HOPE CREEK GENERATING STATION
DOCKET NO. 50-354
DRAFT SAFETY EVALUATION REPORT
OPEN ITEM STATUS

Attachment 1 is a current list which provides a status of the open items identified in Section 1.7 of the Draft Safety Evaluation Report (SER). Items identified as "complete" are those for which PSE&G has provided responses and no confirmation of status has been received from the staff. We will consider these items closed unless notified otherwise. In order to permit timely resolution of items identified as "complete" which may not be resolved to the staff's satisfaction, please provide a specific description of the issue which remains to be resolved.

Enclosed for your review and approval (see Attachment 4) are the resolutions to the Draft SER open items listed in Attachment 3.

FIGURE 430.48-1
SHEET 12 OF 21
AMENDMENT

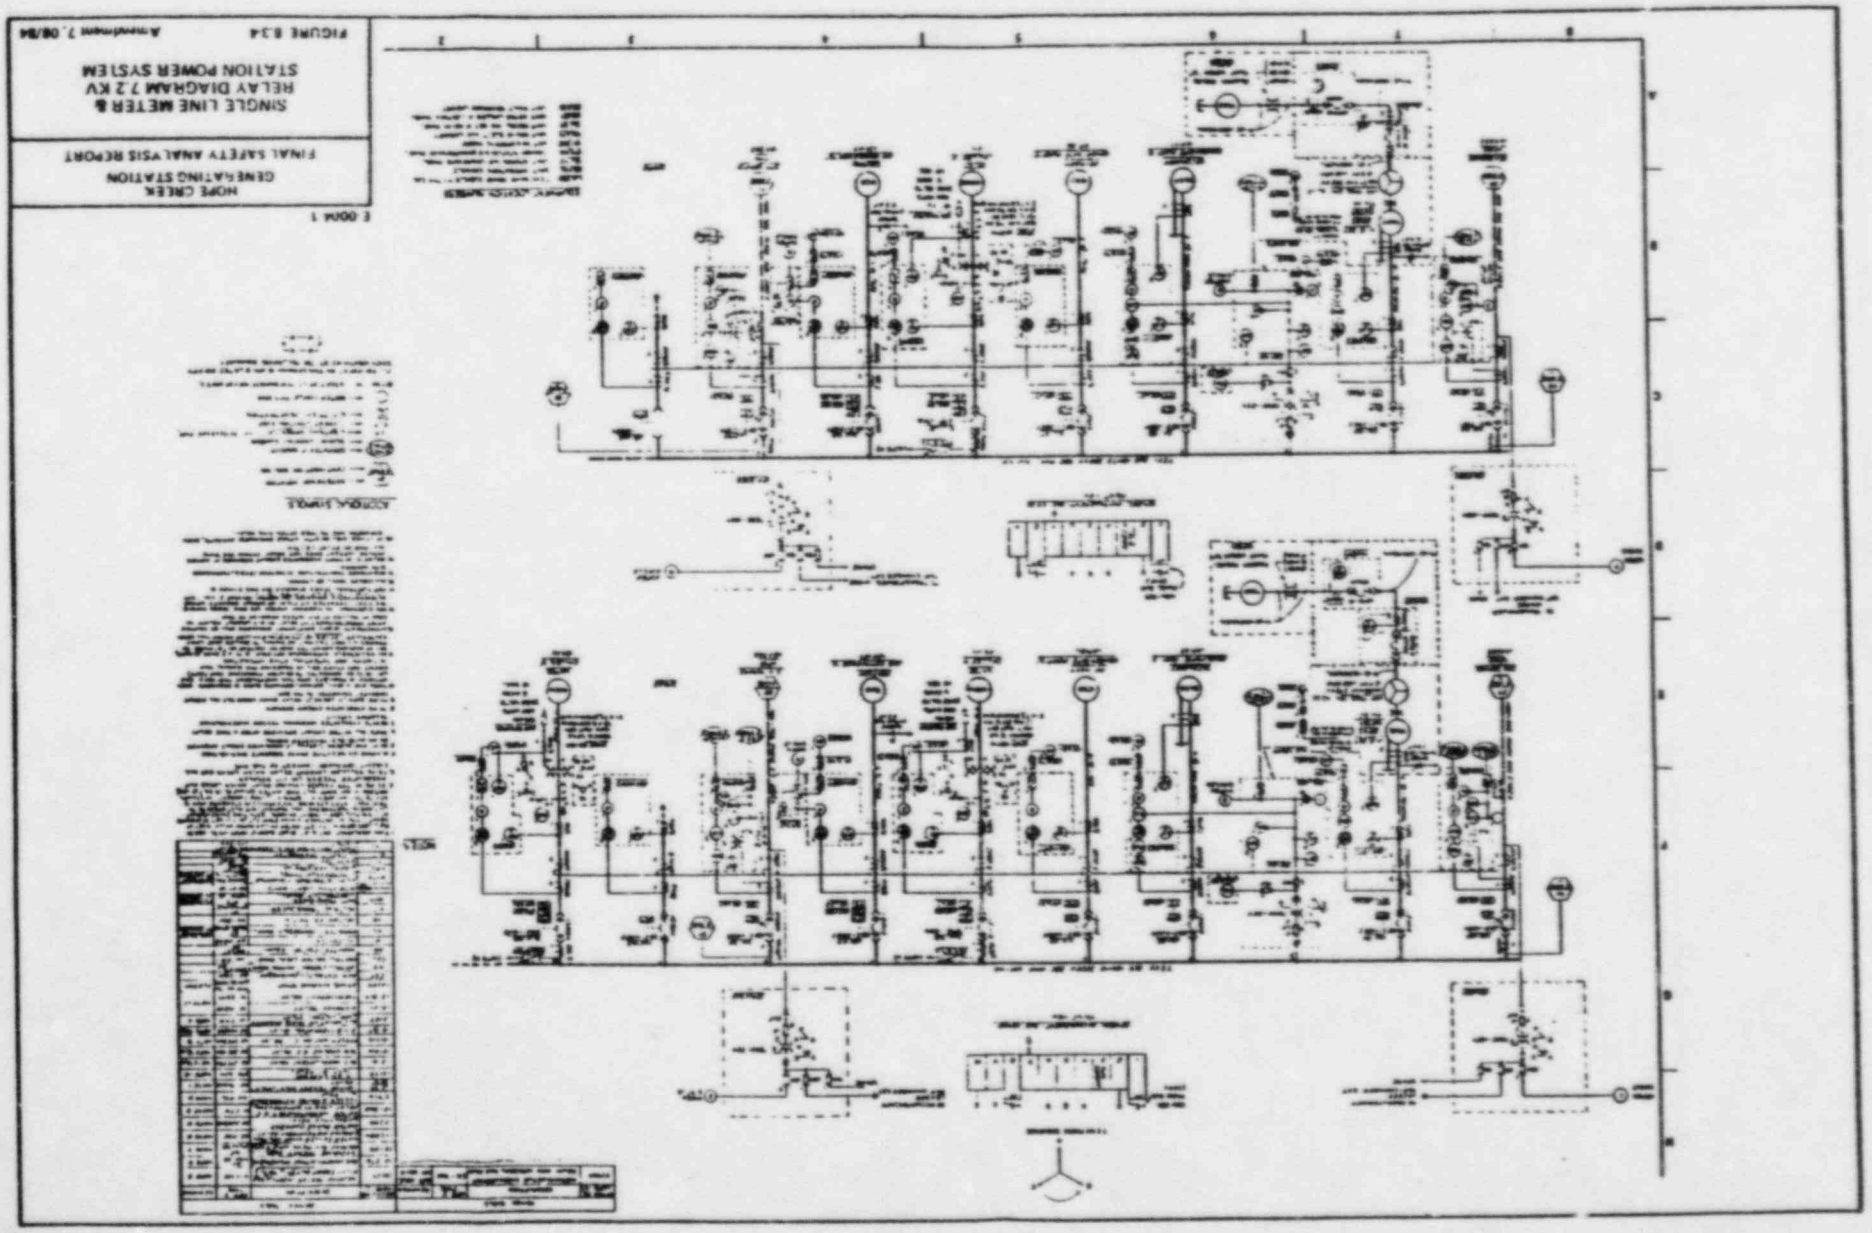
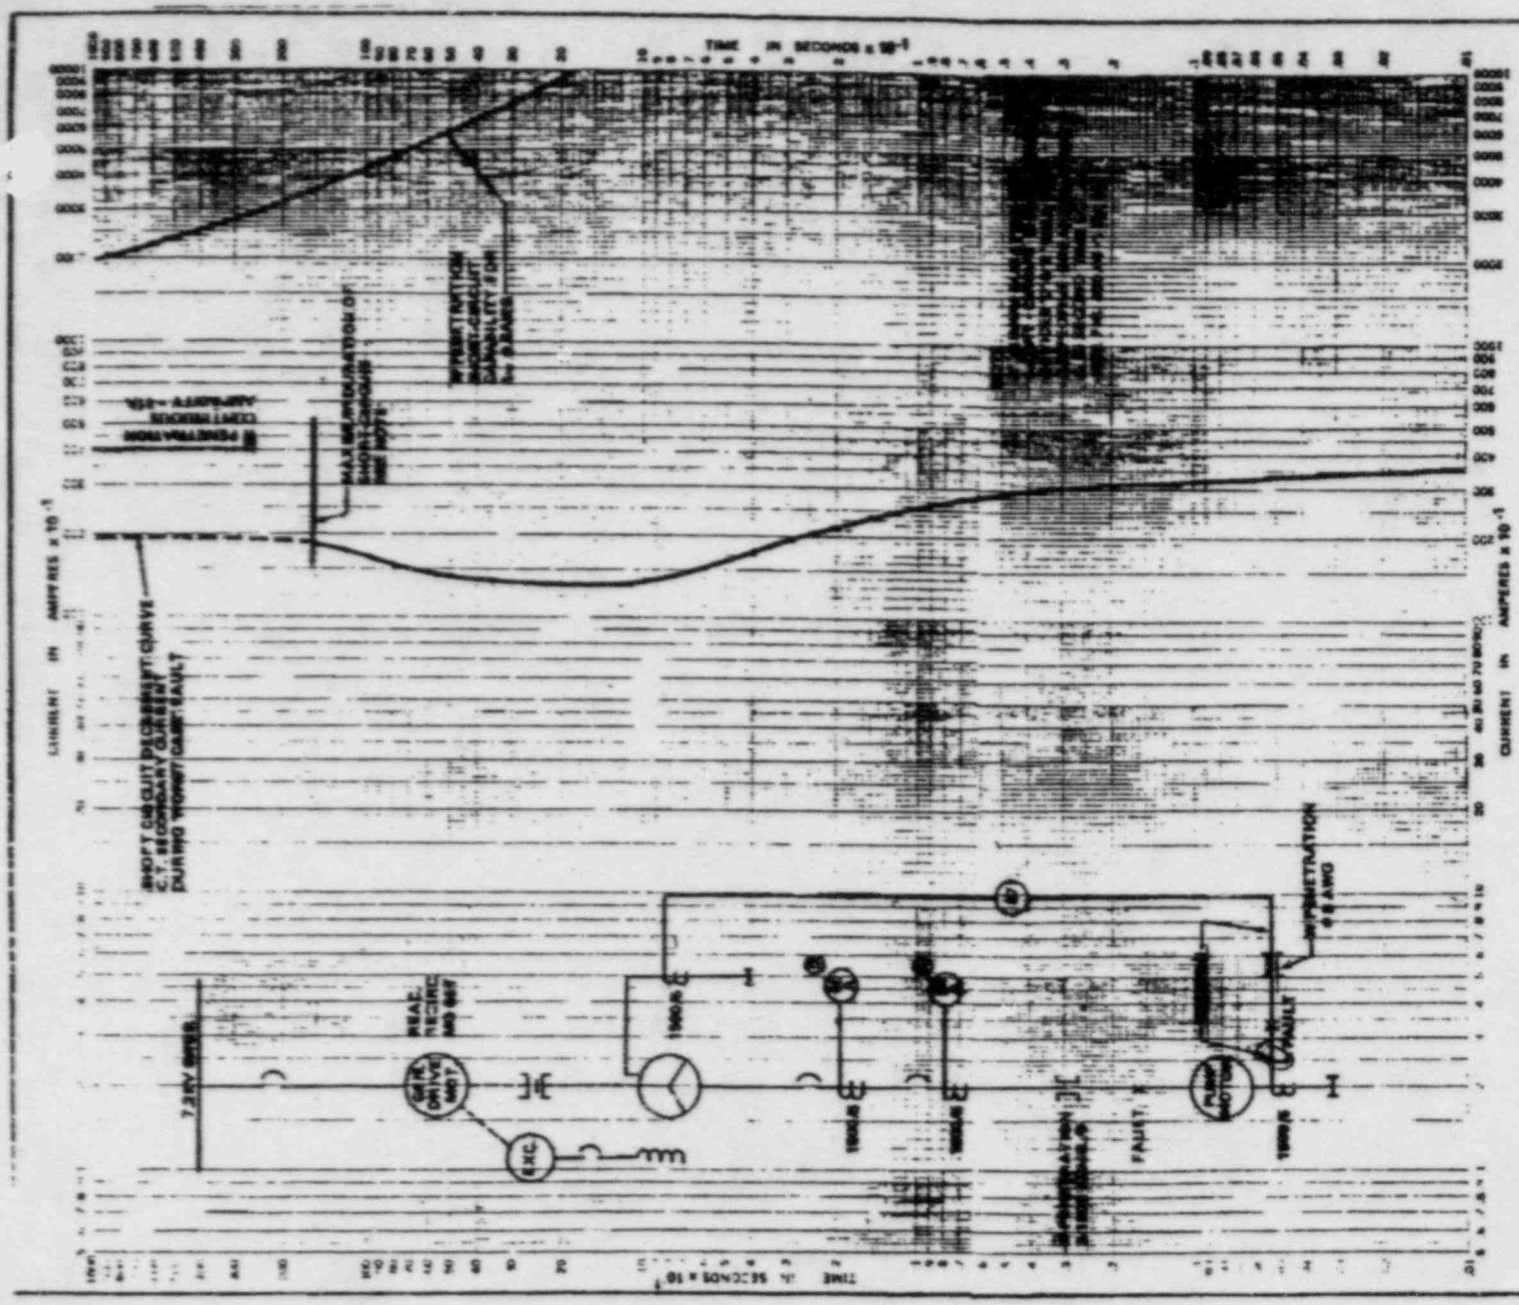
By Amendment 4 to the FSAR, the applicant indicated that coordinated fault-current versus time curves for representative penetration conductors and their protective devices are included in Figures 420.46-1 of the FSAR. Based on a review of these figures, the staff concludes that representative curves for motor differential relay, current transformer, and instrumentation circuits were not included in Figure 430.46-1. Inclusion of these circuits as well as other circuits such that the coordinated fault-current versus time curves is representative of all penetration circuits will be pursued with the applicant.

b. Provide coordinated fault-current versus time curves for each representative type cable that penetrates primary containment. For each cable, the curves must show the relationship of the fault carrying capability between the electric penetrations, the primary overcurrent protective device, and the backup overcurrent protective device.

RESPONSE

FSAR Section 8.1.4.12 has been revised in response to Question 430.46, and to address this concern.

FIGURE 430.48-1
SHEET 11 OF 21

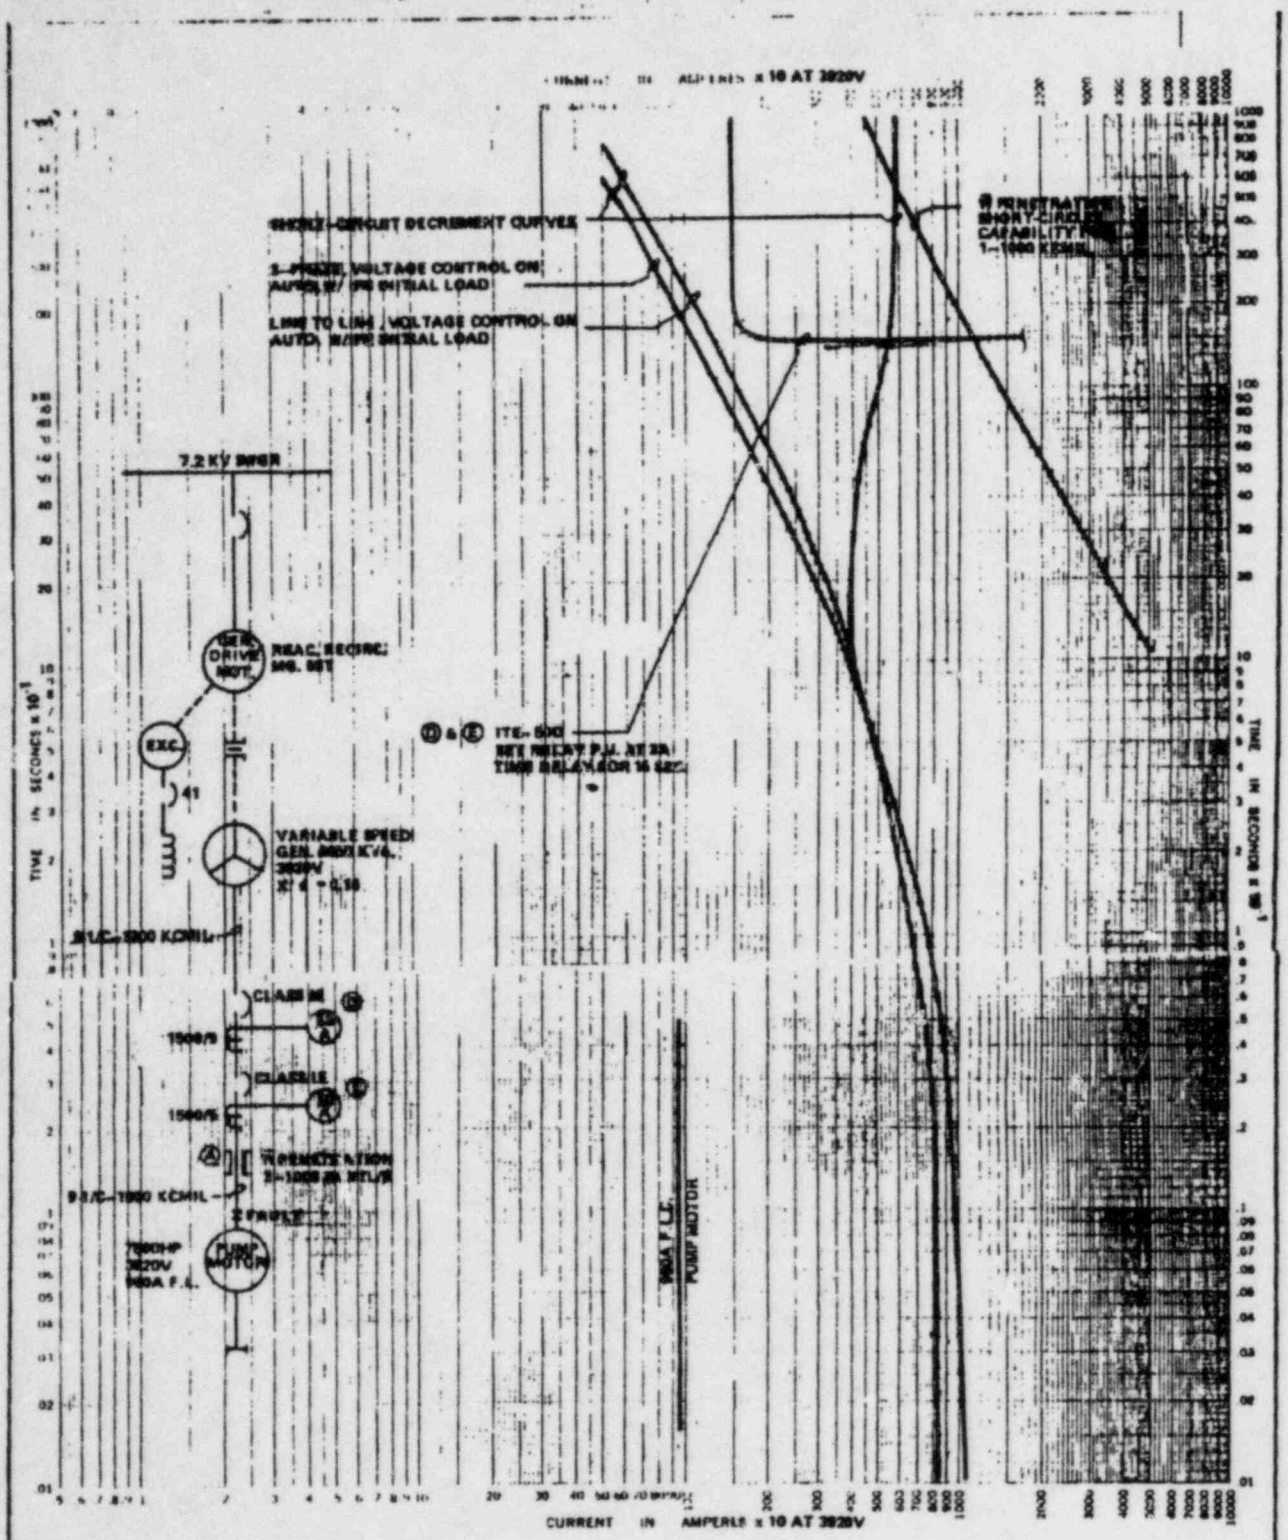
THE USE OF A SINGLE BREAKER TO PROVIDE PENETRATION PROTECTION

Figure 8.3-17, Sheet 11, has been provided to show two breakers.

The above cases illustrate that the intent of Reg. Guide 1.63 is met. No single failure of a circuit overcurrent protective device could cause a penetration failure. Refer to the representative curves of Figure 8.3-17.
